**GENOA CHARTER TOWNSHIP
PLANNING COMMISSION PUBLIC HEARING
OCTOBER 9, 2018 (TUESDAY)
6:30 P.M.
AGENDA**

Attention:	Kelly Van Marter, AICP Planning Director and Assistant Township Manager
Subject:	Volunteers of America –Sketch Plan Review #2
Location:	2700 E. Grand River Avenue – south side of E. Grand River, east of Chilson Road
Zoning:	GCD General Commercial District

Re: Volunteers of America Sketch Plan Review #2

SITE PLAN

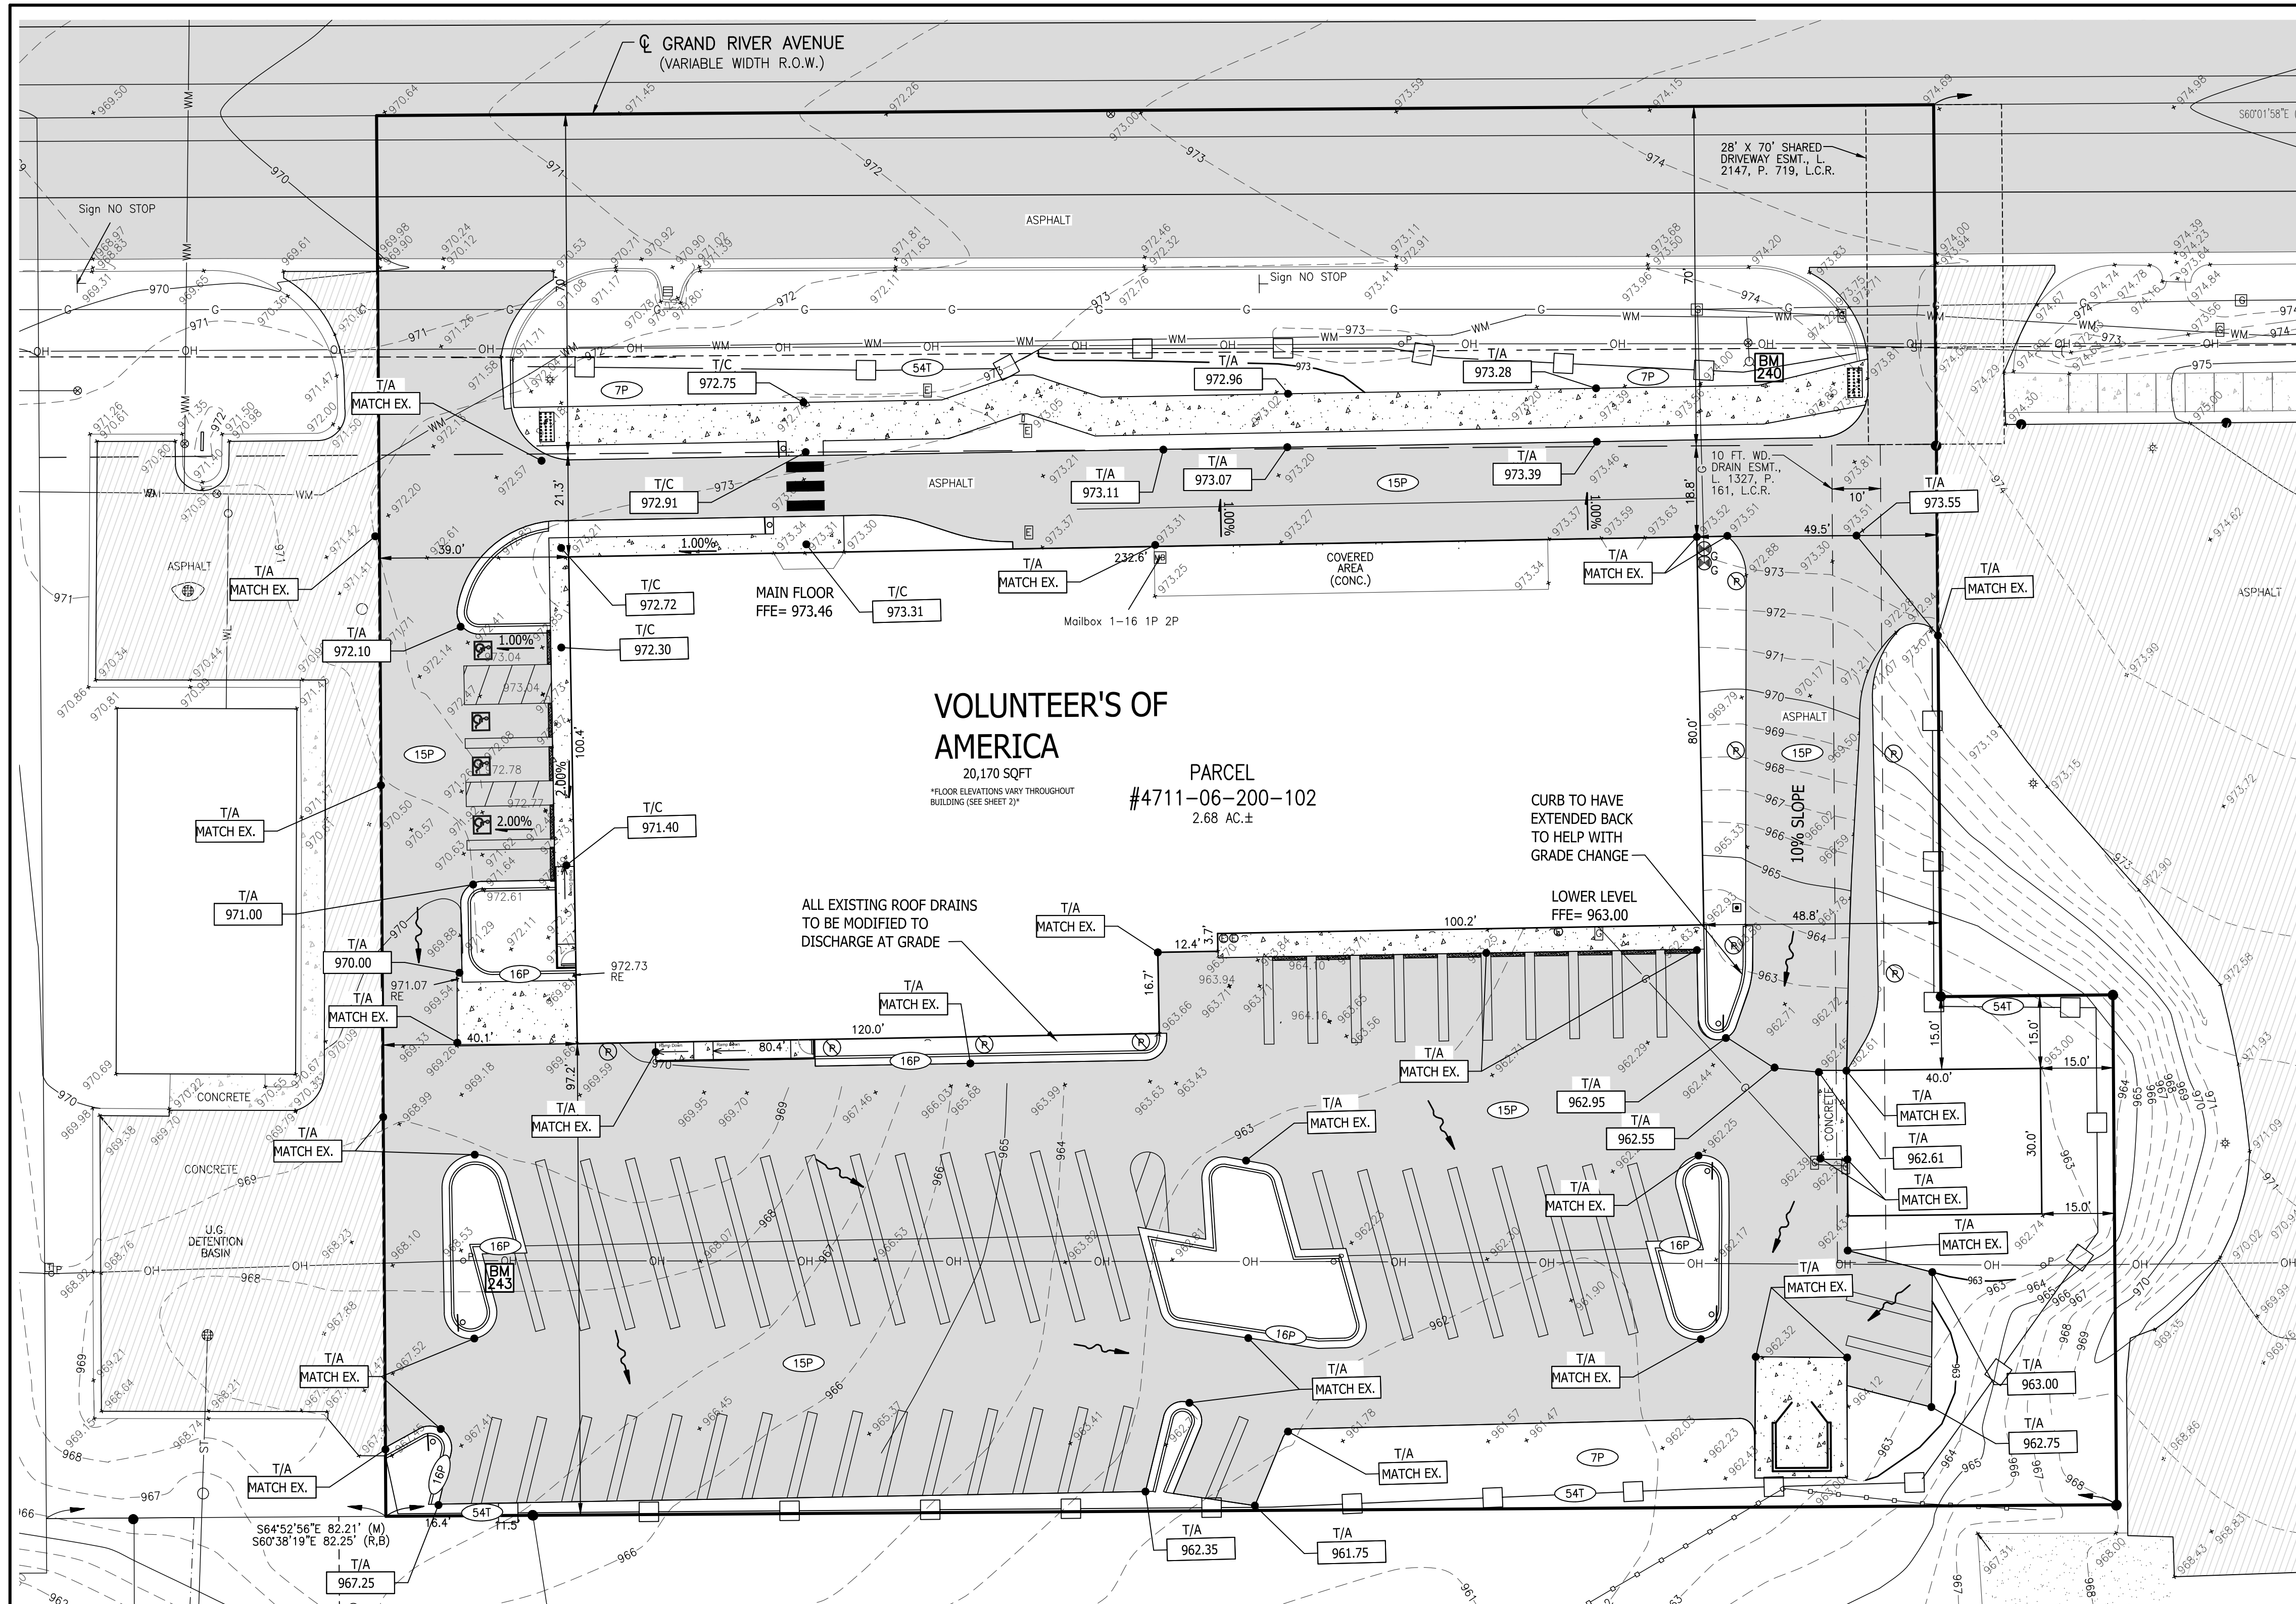
1. **Dimensional Requirements.** The only dimensional standard impacted by the proposal is a new row of parking along the rear lot line. This element of the project does not provide the required setback (10’); however, Section 14.06.11 allows the Commission to reduce or waive this requirement given the presence of a shared access driveway.

As a side note, the site impervious/pervious narrative on Sheet 3 indicates an overall decrease in impervious surface lot coverage as a result of the project.

4. Pedestrian Circulation. The revised plan includes the required 8-foot wide bike path, along with internal sidewalks around the building between parking/drives and the building itself.

As was discussed at the previous meeting, the applicant has also added a crosswalk connecting the public sidewalk with the building entrance.

4. Access around building shall provide emergency vehicles with a minimum turning radius 30'-inside and 50'-outside. **(Noted on Sheet 3)**
5. A minimum vertical clearance of 13 ½ feet shall be maintained throughout the site. **(Noted on Sheet 3)**

8. The building shall include the building address on the building. The address shall be a **minimum of 6"** high letters of contrasting colors and be clearly visible from the street. The location and size shall be verified prior to installation. **(Noted on Sheet 3)**
IFC 505.1

9. The location of a key box (Knox Box) shall be indicated on future submittals. The Knox box will be located adjacent to the front door of the structure. **(Location identified at the main entrance on Sheet 3)**
IFC 506.1

GRADING, DRAINAGE, & SESC PLAN

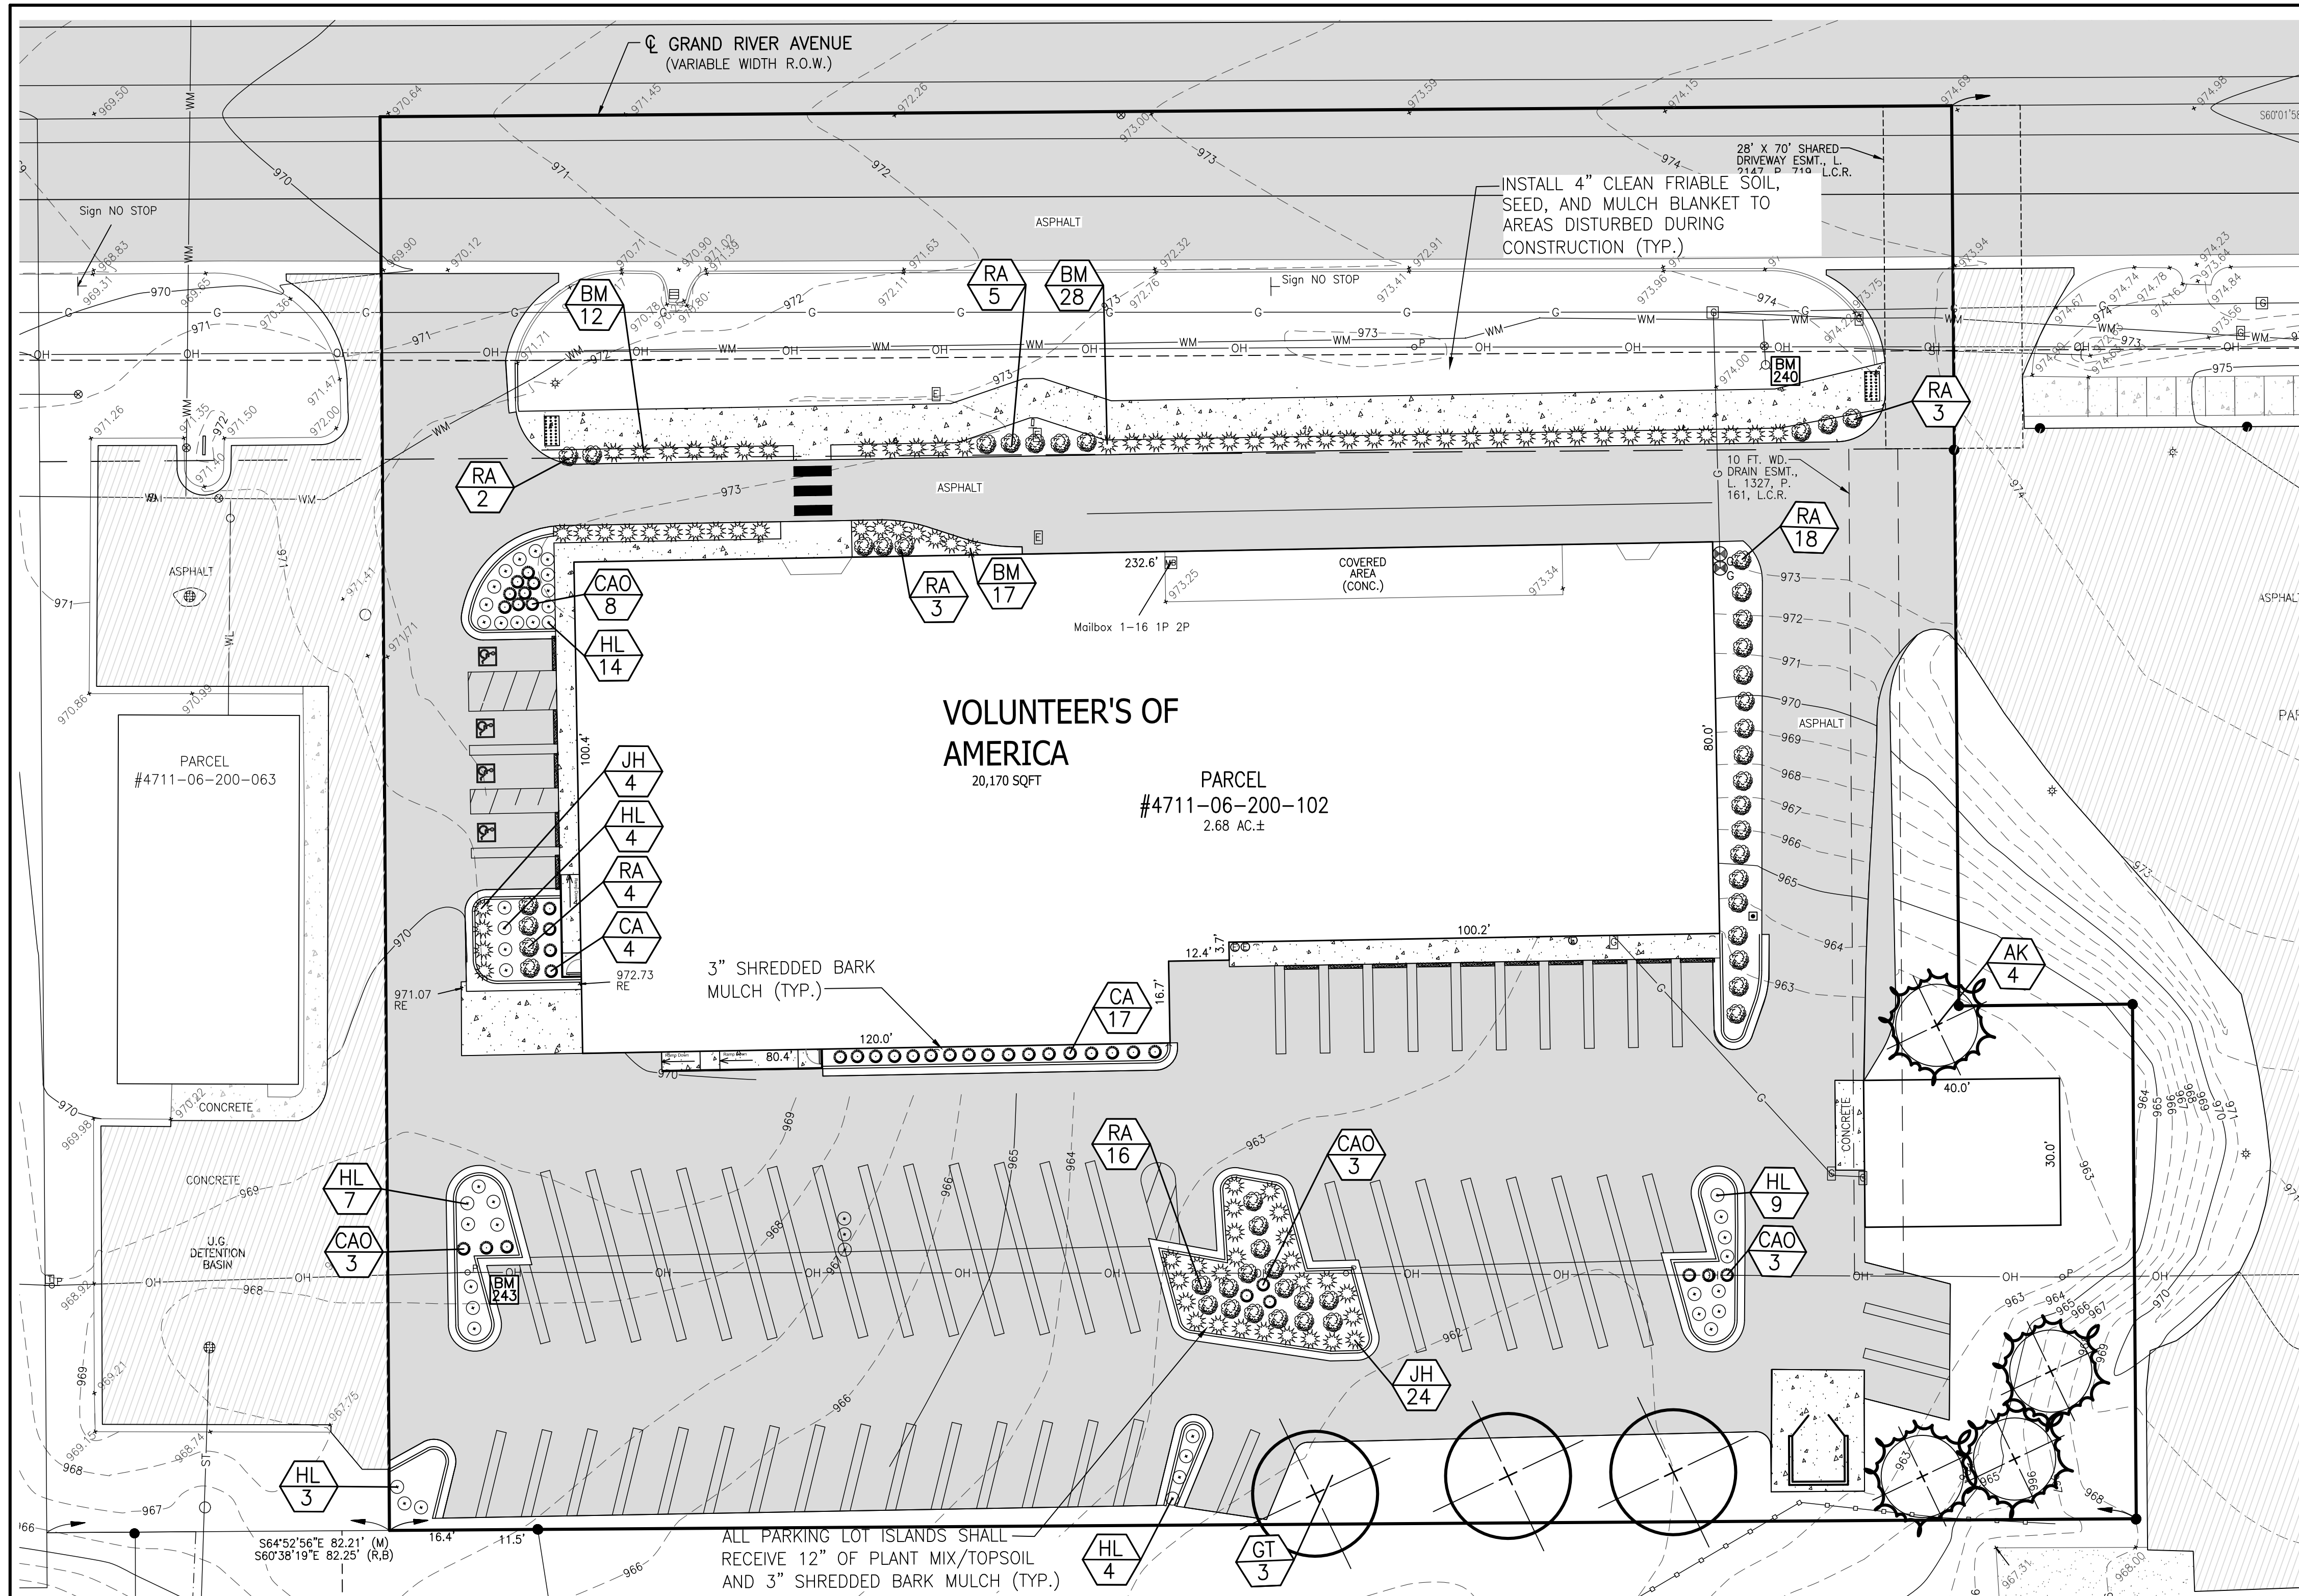
3. Measuring from the highest to the lowest contour line and the distance between them, it is 8/58-feet or approximately 13.8% slope along this drive. The slope along this drive far exceeds the maximum 10% permitted for an emergency vehicle access drive. The slope must be revised to be within permissible limits. **(The slope is shown as 10% on Sheet 3 and the contour line dimensions appear to prove it. When scaled it is slightly less at 9.7% which is acceptable .)**
